IRM Topology Update

- *Dover PAR Delay*

NYISO

ICS #281

2024 – 2025 IRM PBC Topology for New York Control Area

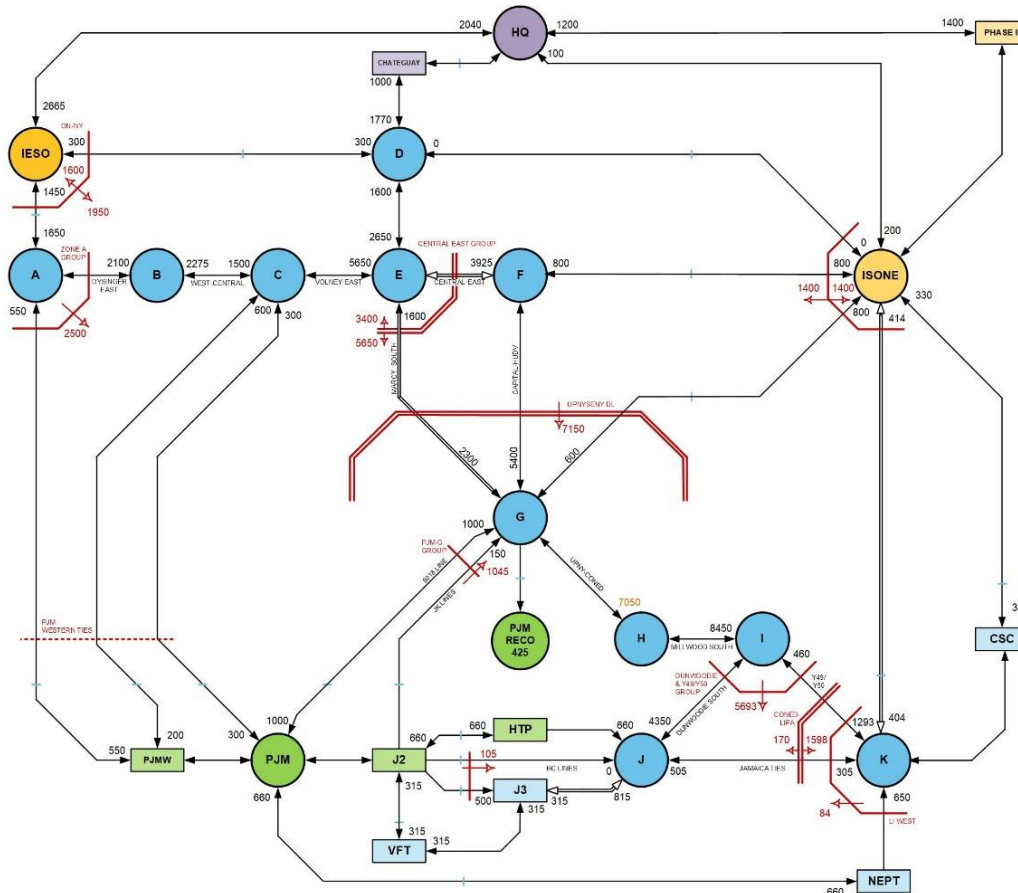
- The delay of the Dover PAR is expected to affect the Central East voltage limit due to the bypassing of the PAR and series compensation at Knickerbocker
- NYISO Operations has updated the Central East Voltage Limits and showed a small reduction from the current IRM assumptions ([Updated Central East Voltage Limits](#))
- NYISO tested the updated Central East Voltage Limits on this year’s PBC and confirmed no IRM impact due to the change
 - Proportional adjustments are also applied to the limit of Central East + Marcy group

- **Bypassing of the Dover PAR and series compensation at Knickerbocker will also impact the UPNYSENY transfer limit**
- **Detailed study about the reduction on the UPNYSENY transfer limit, as compared to AC Tx fully in service, has not been completed**

- Reverting the improvement on UPNYSENY transfer limit represents 1900 MW reduction on the PBC assumption
- **Given the lack of completed detailed study and the expectation of no impact on the IRM study, the NYISO propose to make no change to the UPNYSENY transfer limit in the 2024-2025 IRM FBC to account for the delay of Dover PAR**

Forward Limits (MW)	Central East	Central East + Marcy Group
2024 – 2025 IRM PBC	3925/3875/3815/ 3710/3595/3470	5650/5575/5490/ 5335/5160/4960
Proposed Change for 2024 – 2025 IRM FBC	3885/3805/3725/ 3640/3540/3460	5590/5475/5360/ 5235/5080/4945
Delta	-40/-70/-90/ -70/-55/-10	-60/-100/-130/ -100/-80/-15

Updated Transfer Limits for 2024-2025 IRM FBC

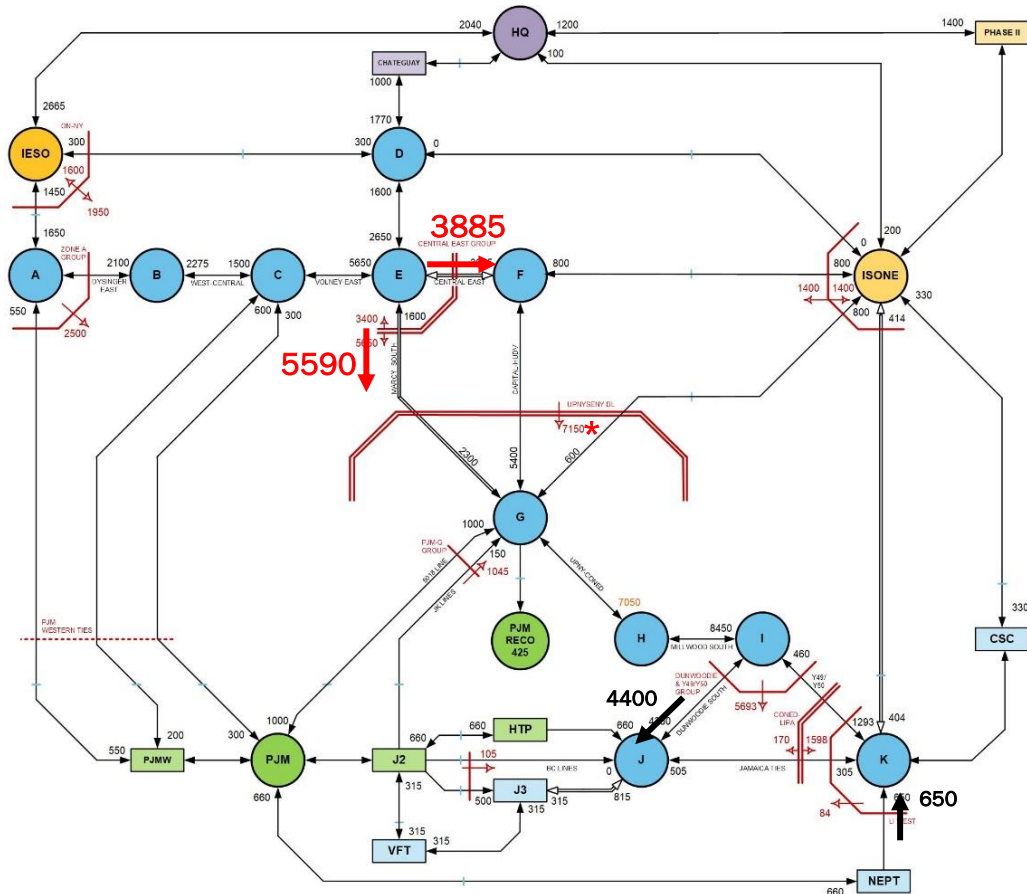
* The UPNYSNY transfer limit is expected to be reduced due to the delay of the construction of DOVER PAR. However, the reduction is not expected to be impactful.

Proposed 2024 – 2025 IRM FBC Topology for New York Control Area

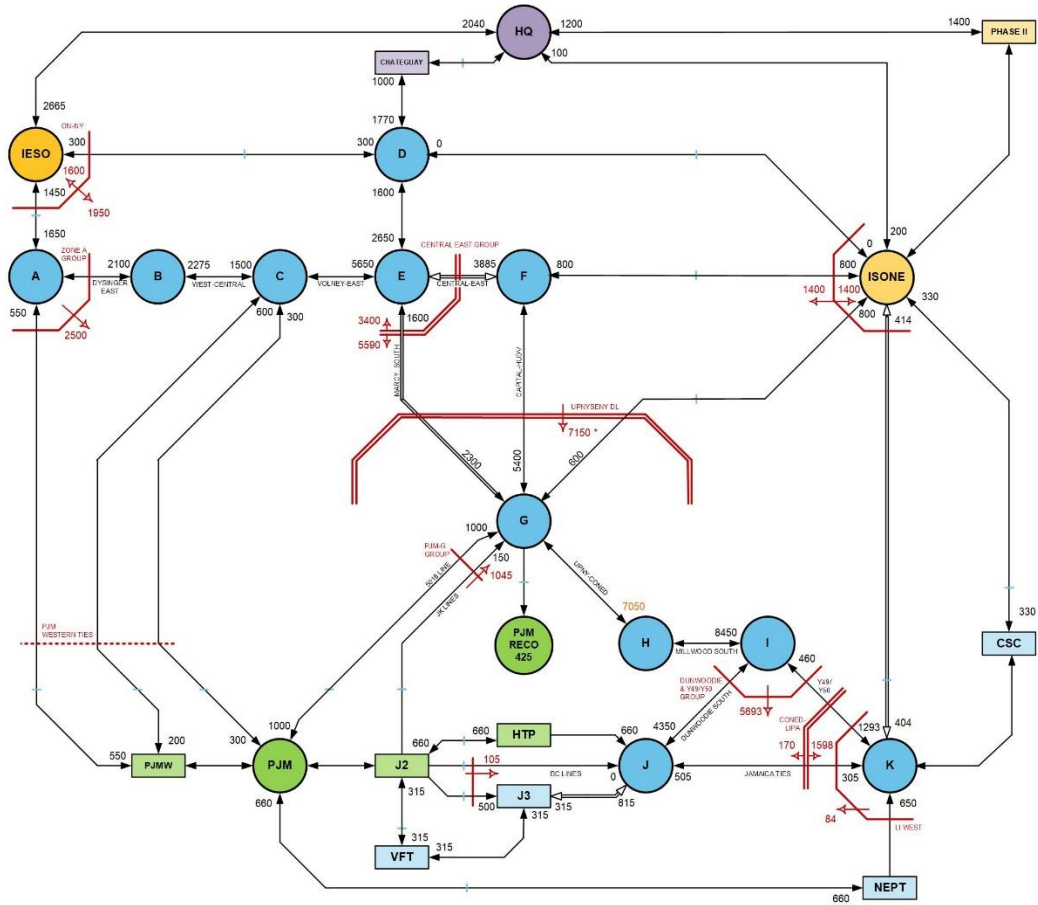
* The UPNYSENY transfer limit is expected to be reduced due to the delay of the construction of DOVER PAR. However, the reduction is not expected to be impactful.
